TOWN OF BROOKLINE  
333 Washington Street, Brookline, Massachusetts 02445

PURCHASE ORDER CHANGE FORM

FOR: Driscoll School Renovation

Driscoll School Project  
Change Order #38 Summary

### SKE-0.25

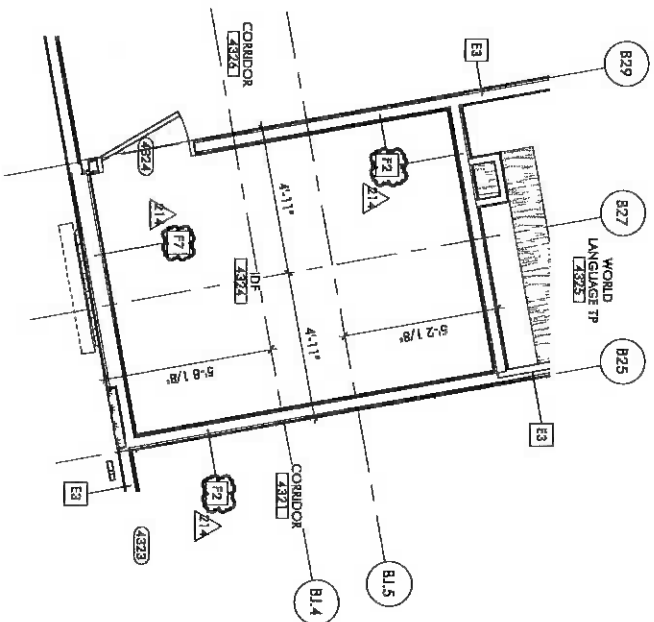
1. Provide power for ductless split unit in IDF 4226 as indicated.

1 ASI #080 - FOURTH FLOOR PIPING PLAN  
1/8" = 1'-0"

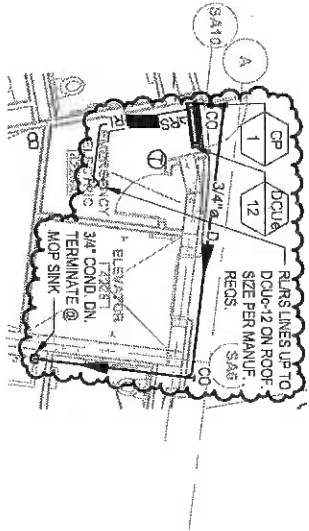
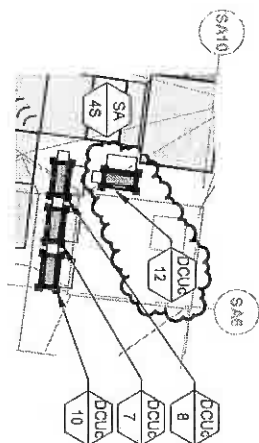
1. Install a ductless split AC unit in IDF 4226 as indicated on the attached sketches.

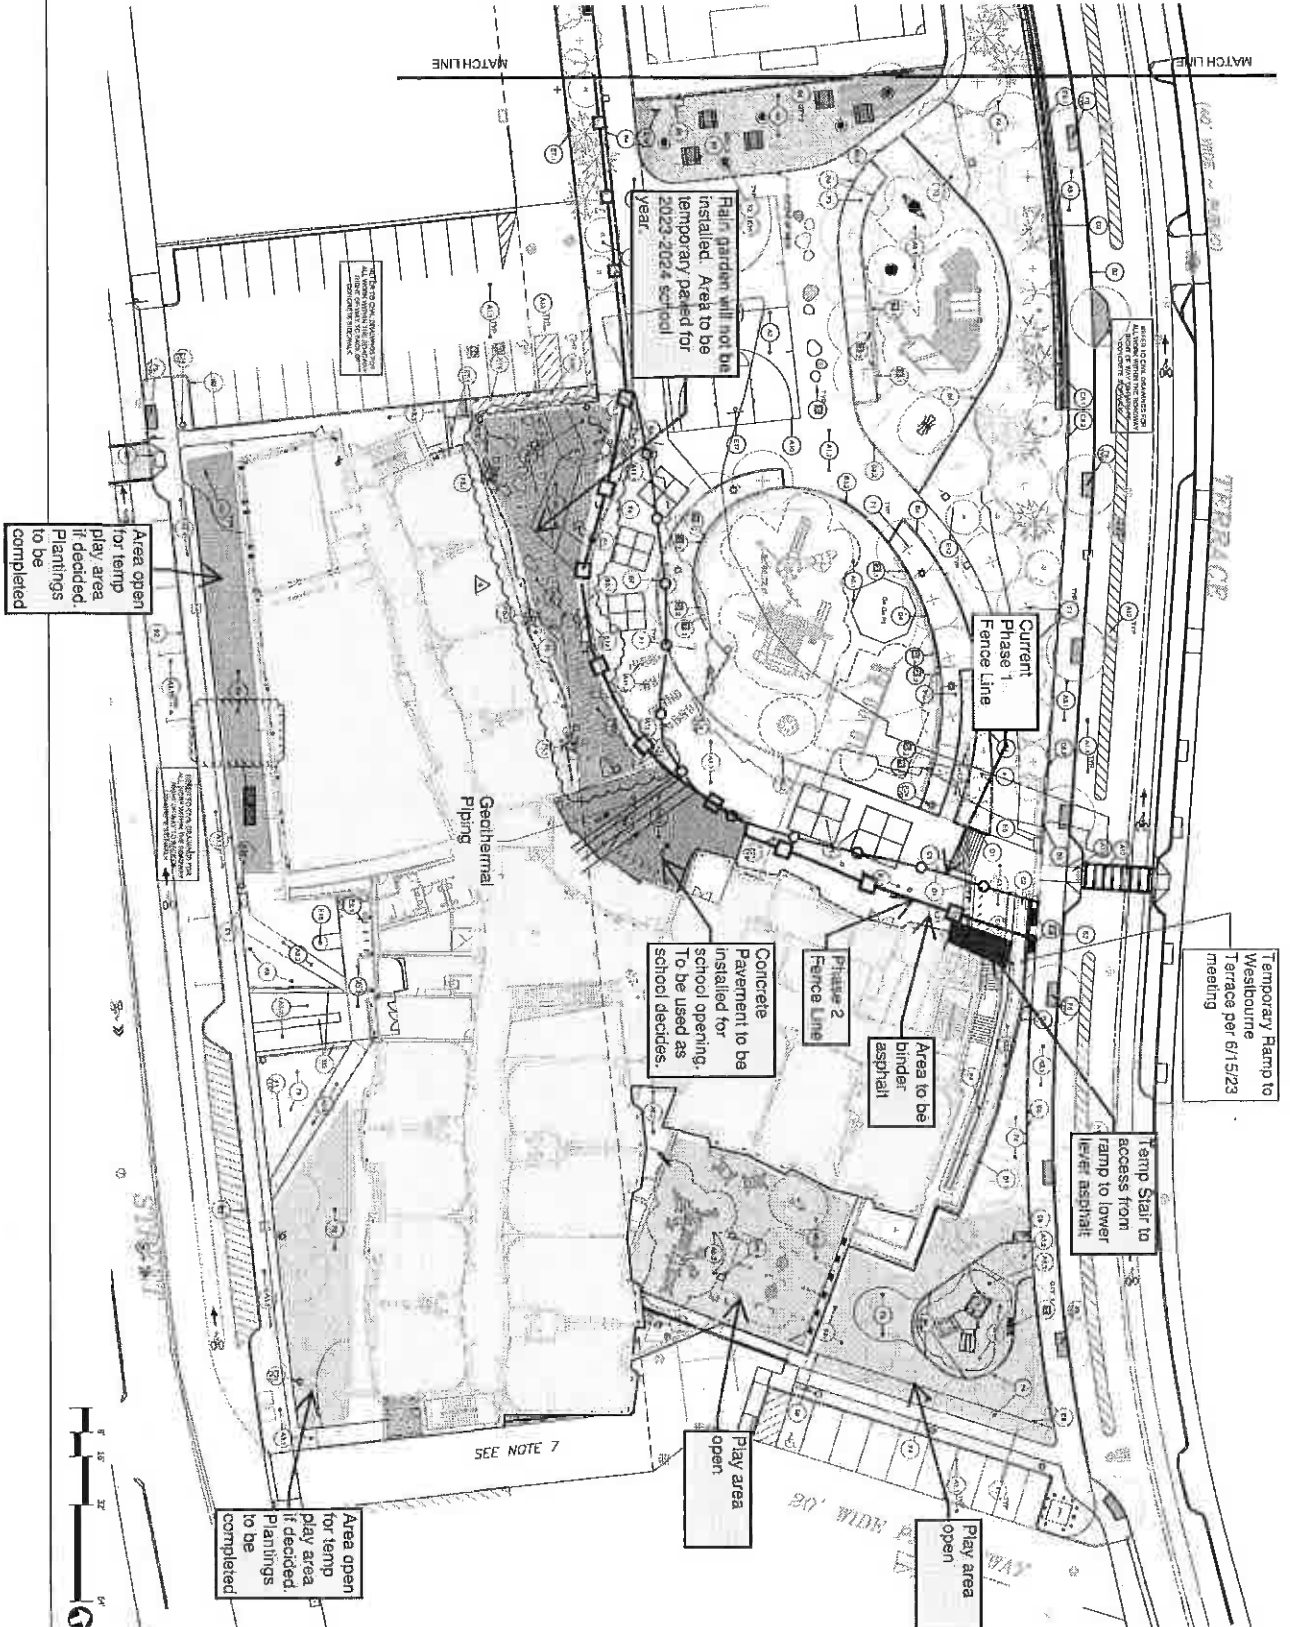
Please see attached marked up drawing regarding temp play areas and other conditions around the building for the building turnover as discussed in previous meeting with JLA, Michael Driscoll Staff and GBCo. Please confirm the plan as marked up is correct and matched the expectations as discussed in the meeting.

Confirmed as noted; refer to attached JLA comments.

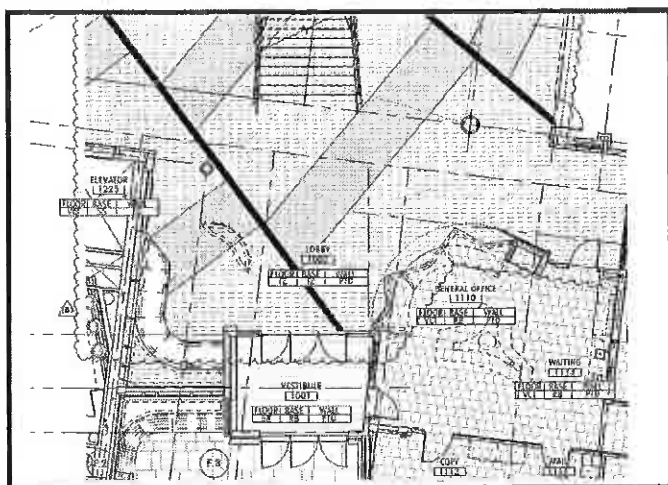
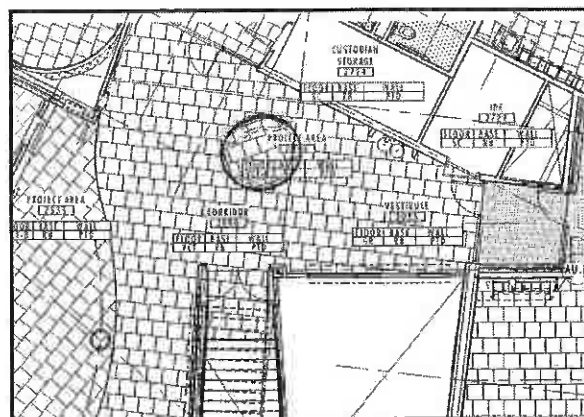
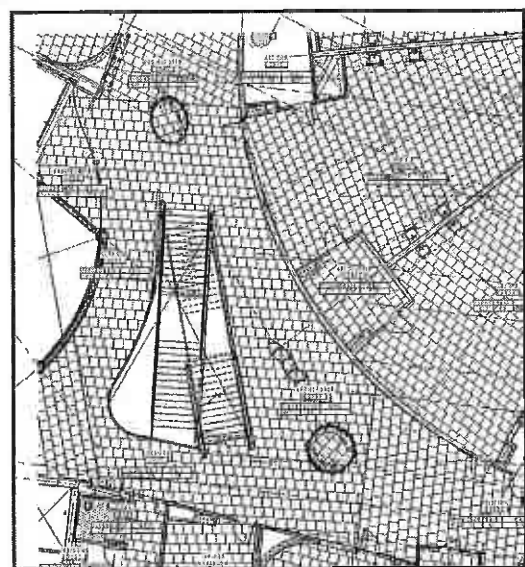
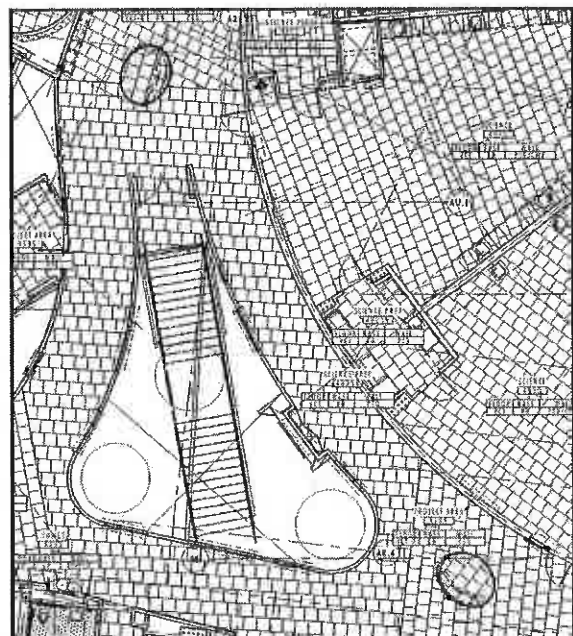
1. Clarify what benches are to be removed and what to do with them.
2. Provide pattern sketch on how the VCT flooring is to be addressed at deleted benches.

- 1) Refer to following JLA sketch highlighting millwork benches to be deleted at levels 2-4 per owner request.
- 2). VCT flooring patterns in these areas shall remain as shown in finish plans (A140 series).  
Refer to PR-028. Installed benches (to be removed) may be used as a reference template.
